Notice

- CORRECTION PRODUCTION CHANGE
- SERVICE FLASH ADD INFORMATION
- FOR RoHS

Category : Megapixel Camera		Date : Mar. 2010
Model Name	Reference No.	Destination
VDC-HD3100P	SM5310799	Europe, U.K., Southeast Asia
VDC-HD3100	SM5310799	U.S.A., Canada, Brazil, Taiwan

1-1. REMOVAL OF CABINET

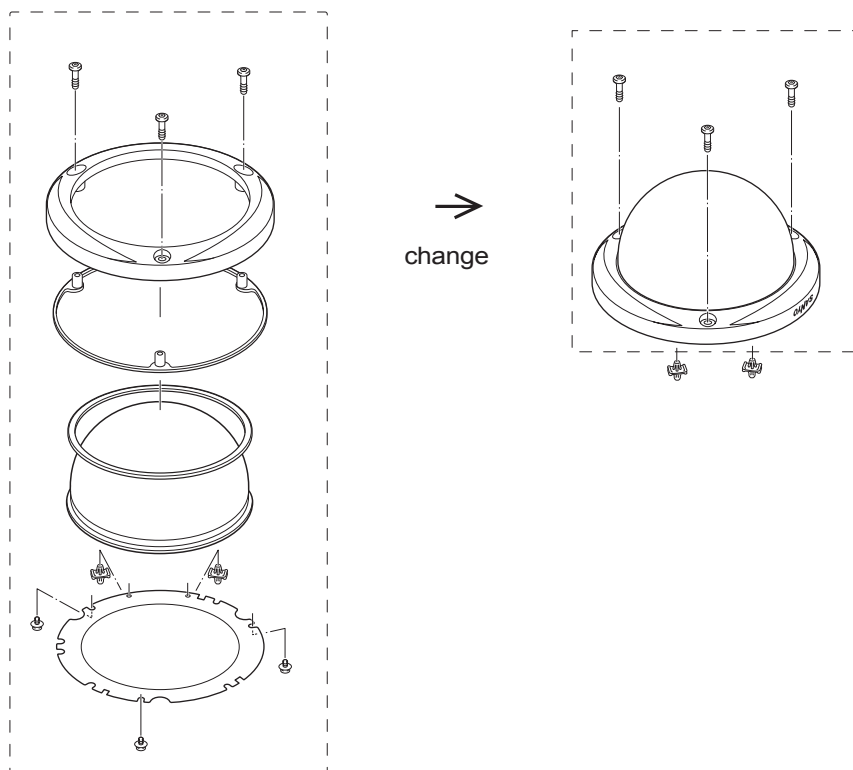
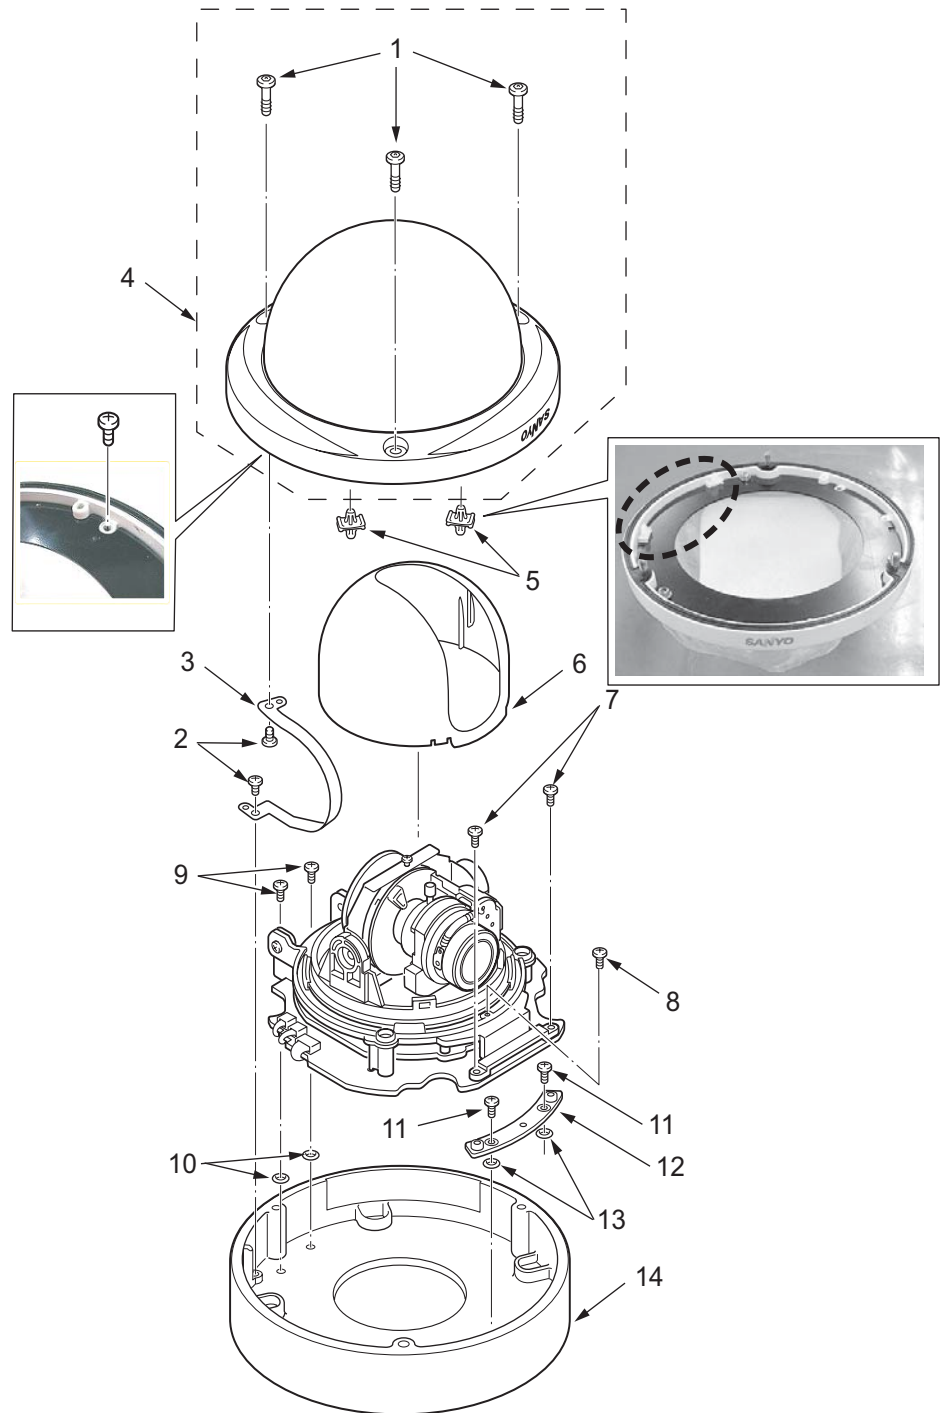
PAGE 5

REASON: B (Image quality)

- 1. Three special screws
- 2. Two screws 3 x 4
- 3. Holder safety
- 4. Assy, cabinet top
- 5. Two spacers
- 6. Cover, inner
- 7. Two screws 3 x 10
- 8. Screws 3 x 4
- 9. Two screws 3 x 6
- 10. Two gasket O rings
- 11. Two screws 3 x 6
- 12. Holder CA2
- 13. Two gasket O rings
- 14. Cabinet bottom

1-4. HEATER OPTION BOARD (VA-60H)

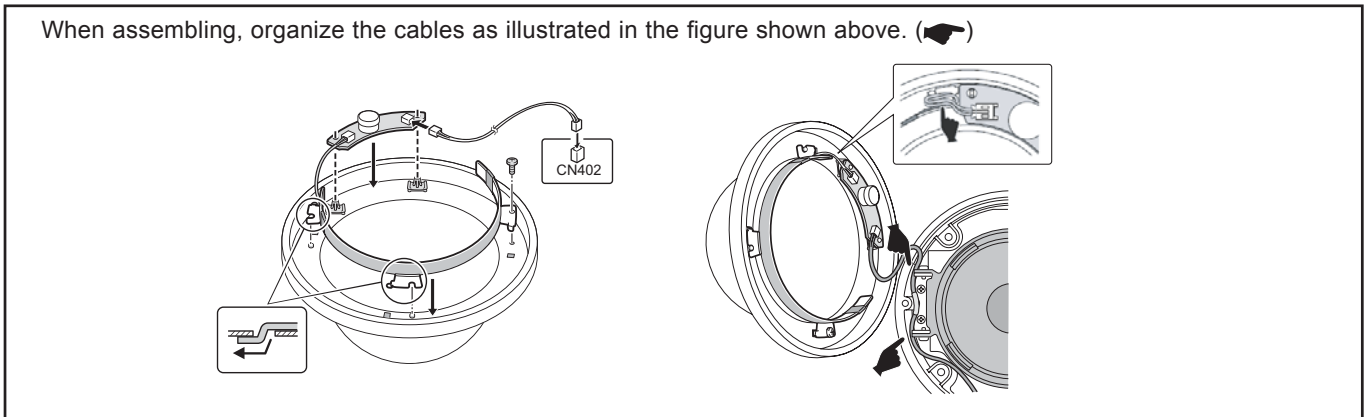
PAGE 8

REASON: A (Misprint)
